Addendum Addenda

Project Description / Description de projet	
S77 4th floor Process Steam Boiler/ Chaudière à vapeur de procédé au 4e étage	
Project No./No de projet	Departmental Representative / représentant ministériel
6092	Eric Poirier
Solicitation No./N° de sollicitation	
22-58138	
Notice: This addendum shall form part of the tender documents and all conditions shall apply and be read in conjunction with the original plans and specifications.	
Nota: Cet addenda fait partie intégrale des dossiers d'appel; toutes les conditions énoncées doivent être lues et appliquées en conjonction avec les plans et les devis originaux.

PROJECT NAME	100 SUSSEX DR. - NRC BUILDING S77 - 4TH FLOOR STEAM BOILER - CNRC BÂTIMENT S77 - CHAUDIÈRE À VAPEUR DU 4ÈME ÉTAGE PROJECT/PROJET NO. 6092
PROJECT NO.	GWAL 2022-471
DATE	MARCH 6, 2023
ADDENDUM NO.	ME1
<p>The following additions, deletions & revisions form part of the drawings and specifications for the above referenced project: Les ajouts, suppressions et révisions suivants font partie des dessins et des spécifications pour le projet susmentionné:</p>

CLIENT NRC			
PROJECT S77 6092 PROCESS STEAM BOILER	1688 Woodward Dr. Ottawa Ontario Canada K2C 3R

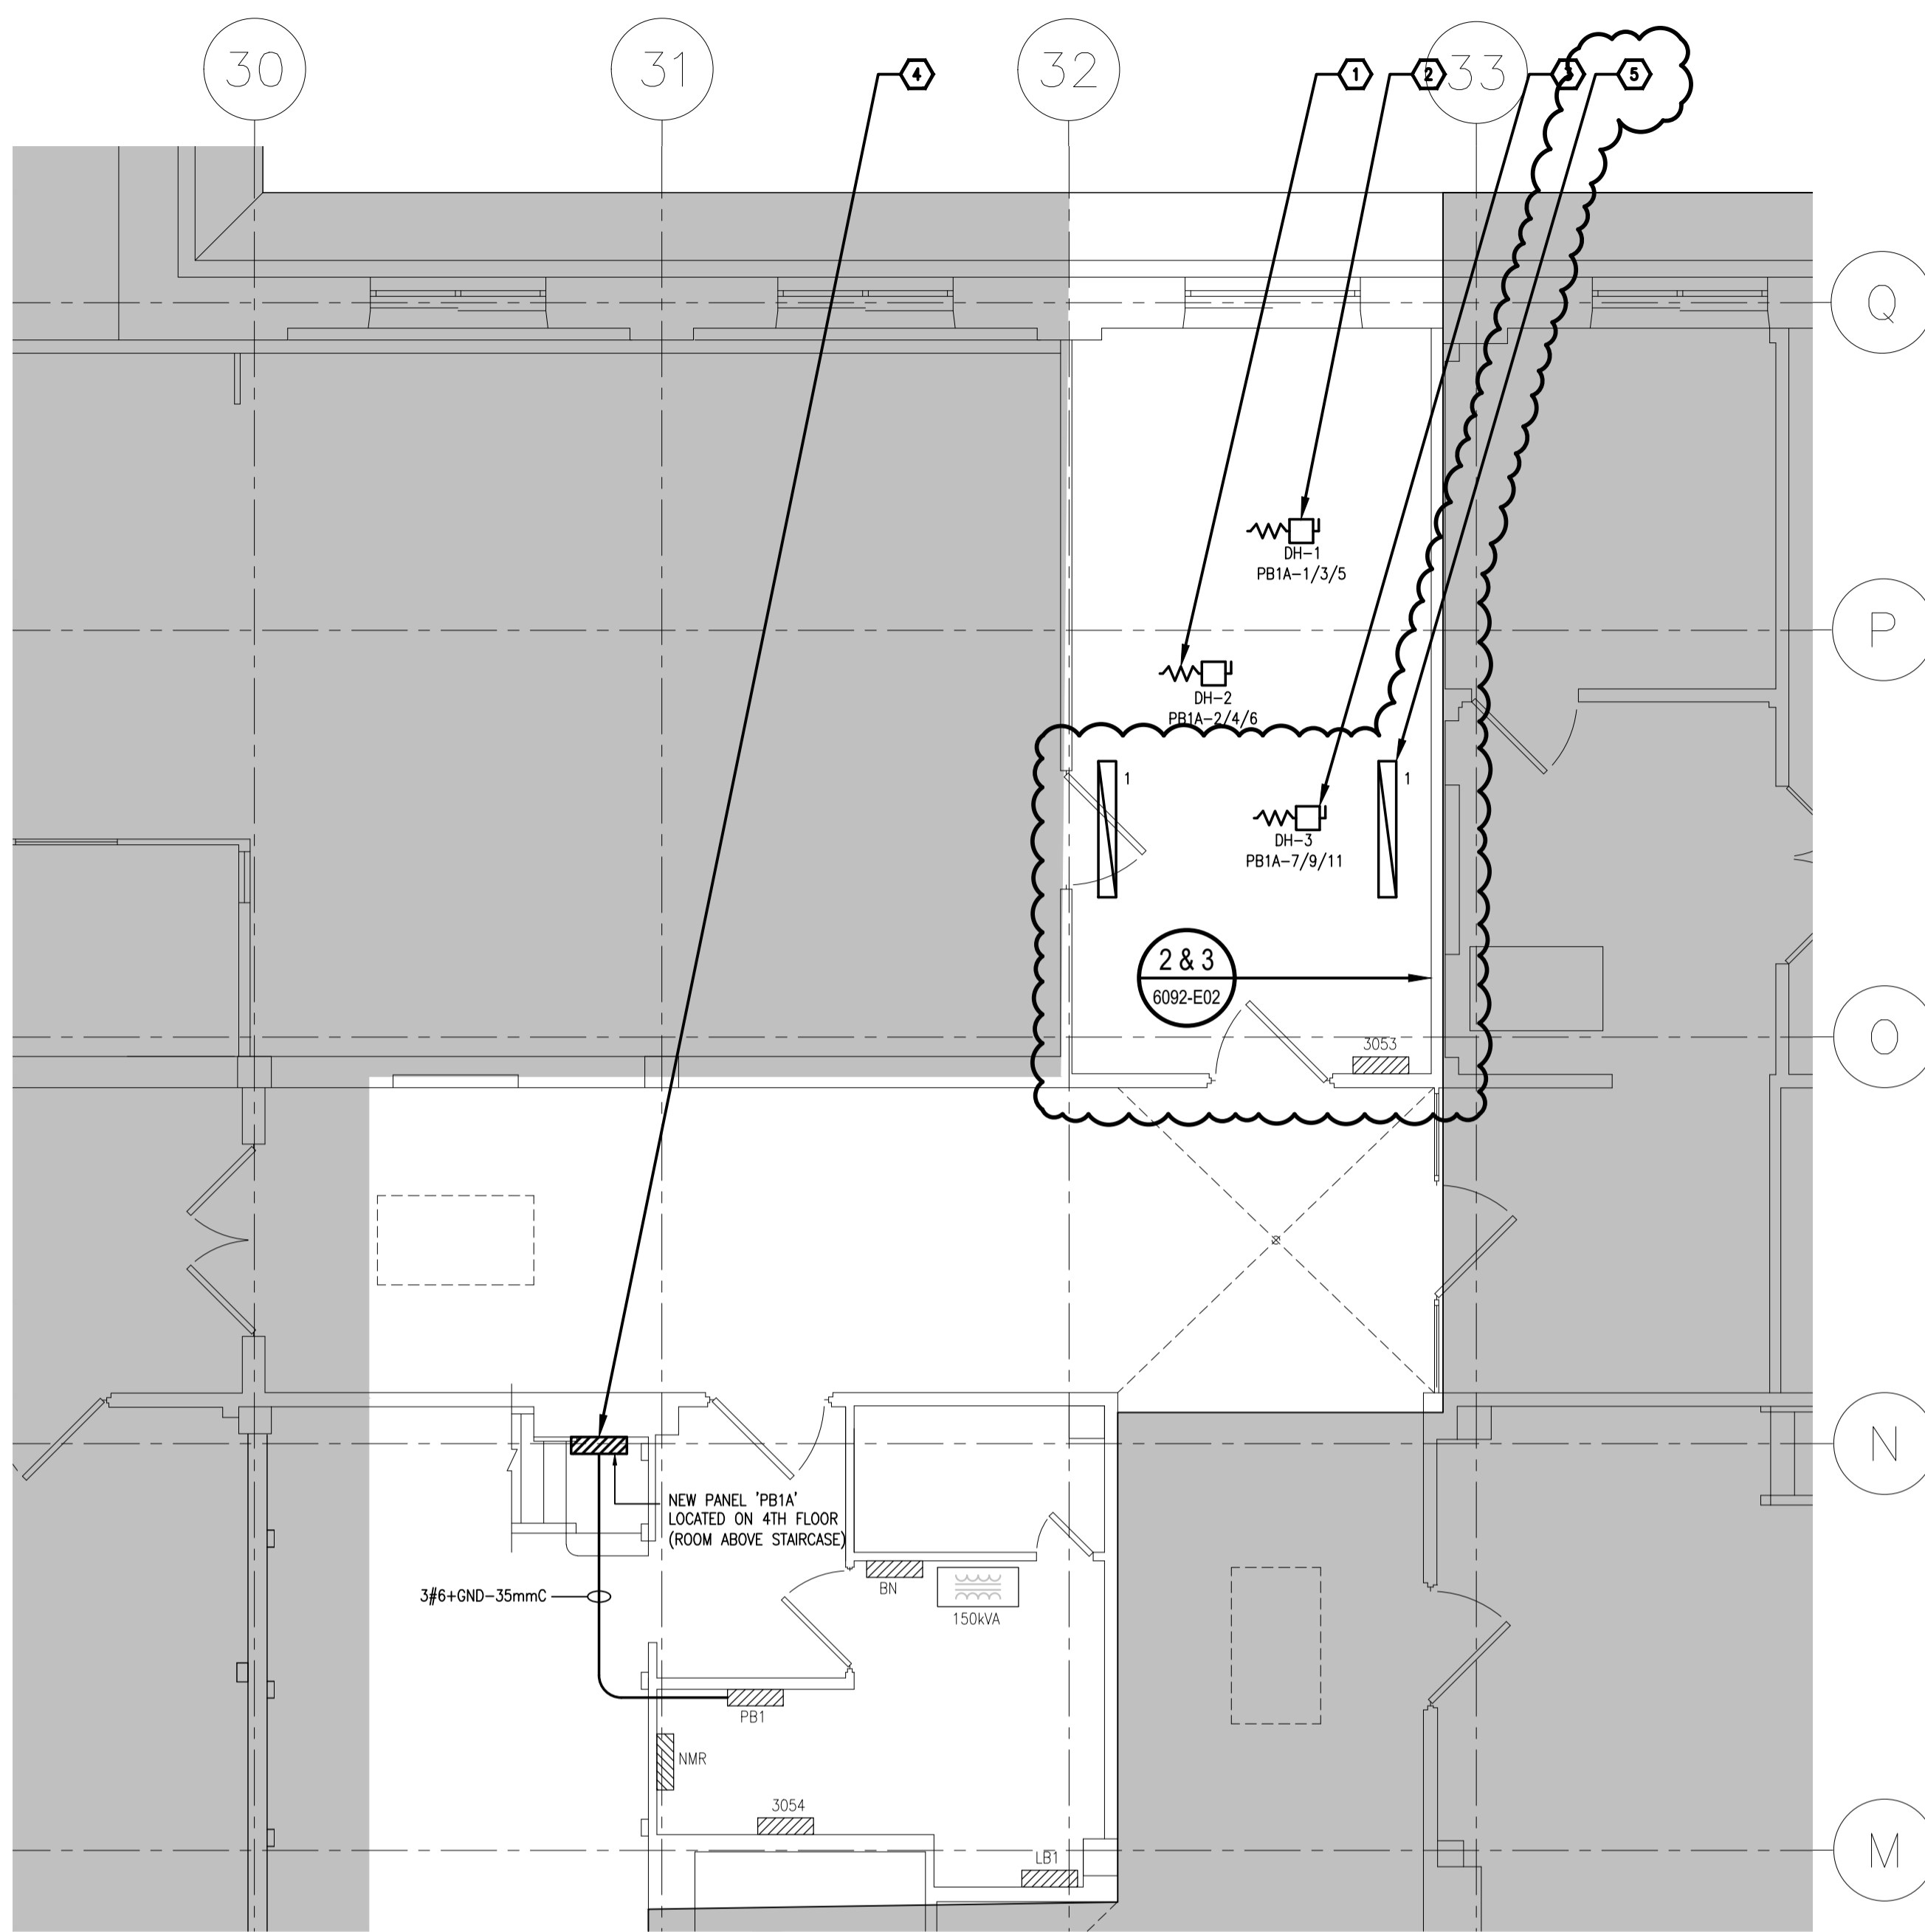
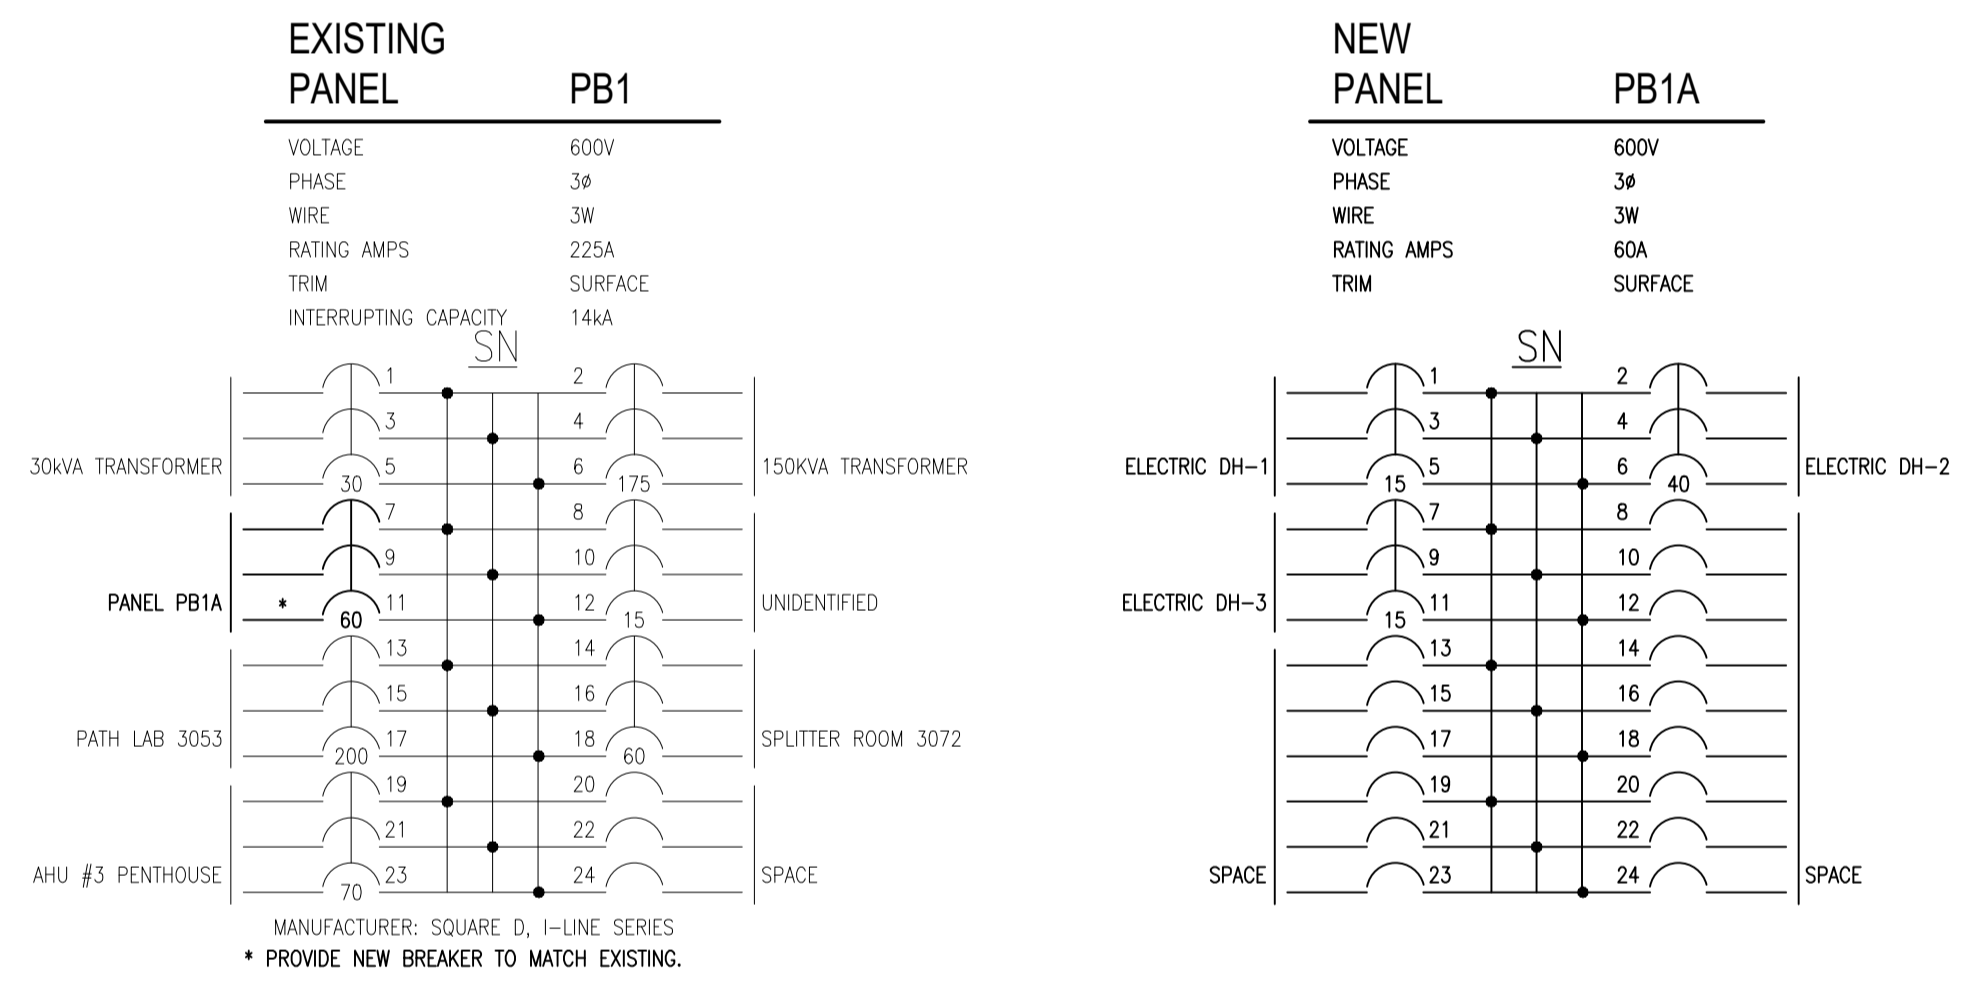
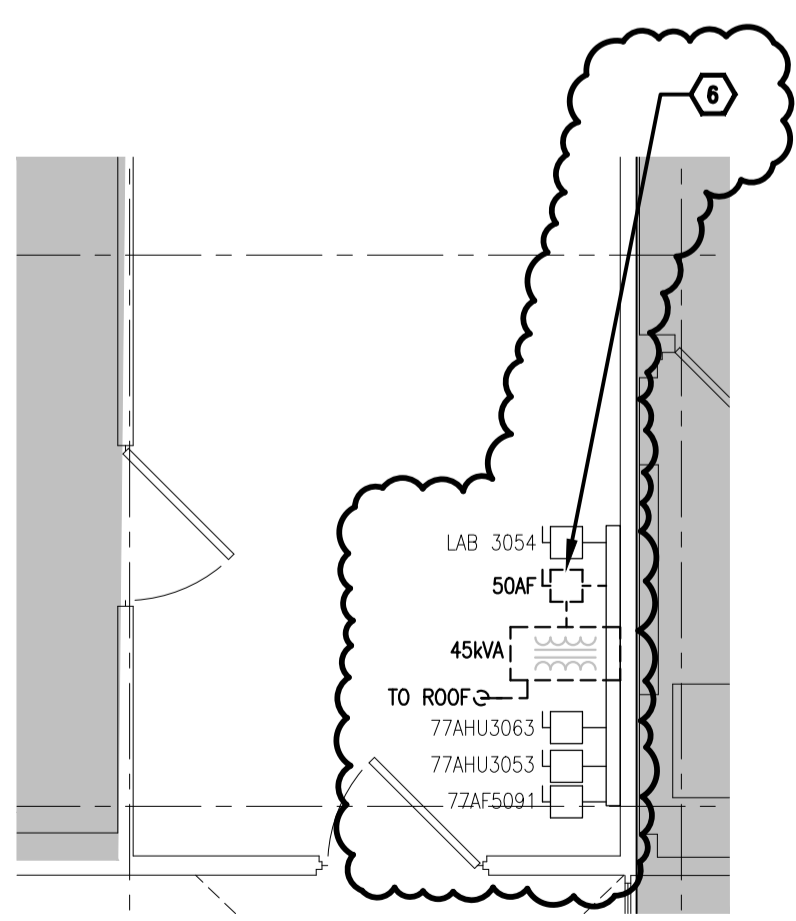
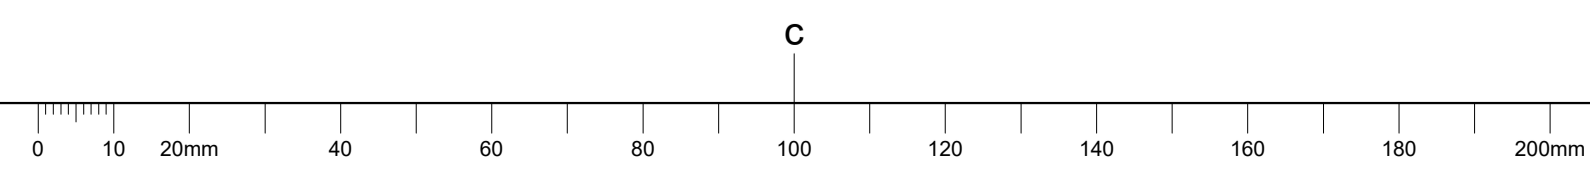
1. **Reference Drawing 6092-M03 and Attached Sketch ADD-M1-SK1:**
 - 1.1 Remove existing steam humidifier as indicated on attached sketch ADD-M1-SK1 c/w all associated piping and accessories. Remove and provide new ductwork as required to suit humidifier removal c/w insulation, lining, and jacketing to match existing conditions.
2. **Reference Attached Revised Drawing 6092-E02:**
 - 2.1 Reference attached drawing for additional demolition.
3. **Reference Drawing 6092-E03:**
 - 3.1 Refer to electrical Panel LA4. Panel manufacturer: Square D, Catalogue number: QO-430, T3C Series.
